# SERVICE BULLETIN #123

## 3560 Spoke Wheel

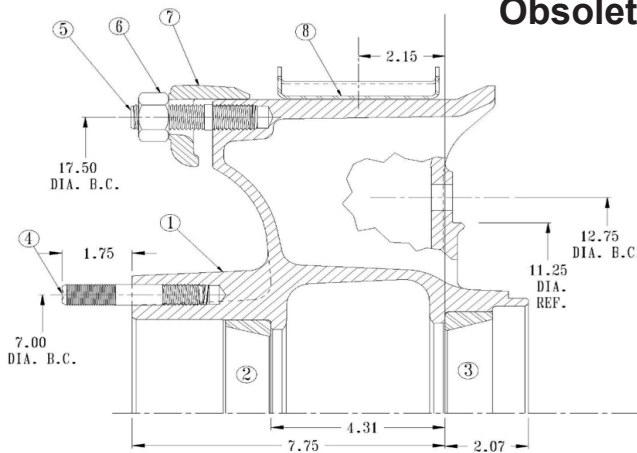
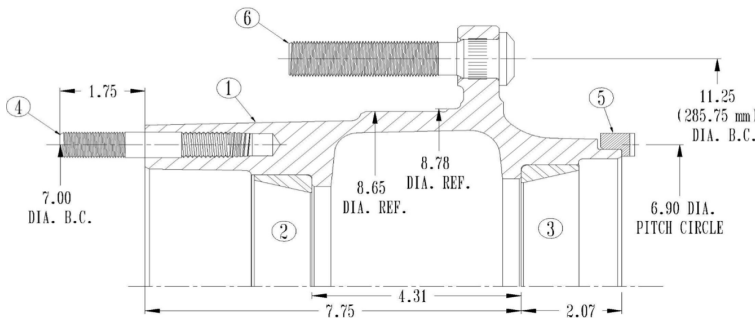
Upon depletion of inventory, the 3560 spoke will become obsolete with no direct replacement. We do however recommend a replacement: the 10-stud 2643 hub. This requires changing brake drums, changing to a disc hub, and changing to disc wheels instead of demountable rims. If you have any questions, please contact the Webb Engineering department via email to [engineering@webbwheel.com](mailto:engineering@webbwheel.com) or call 256-736-6356.

### Replacement Option
